Access Compliance Report Public Rights-of-Way (Curb Ramps)

Main Street: WEATHERBY_RD Cross Street: ORANGEWOOD_AVE Location: SW

ADA ID: RPRK211217121940 Ramp Type: Type 1 - Perpendicular Diagonal Initial Pass/Fail: Pass Overall Compliance: No Severity Score: 4

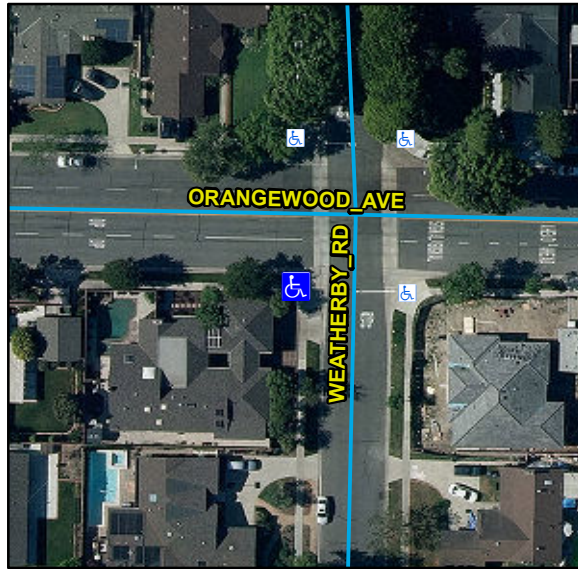
Remove & Replace Landing.

R304.2.1, STD 1115
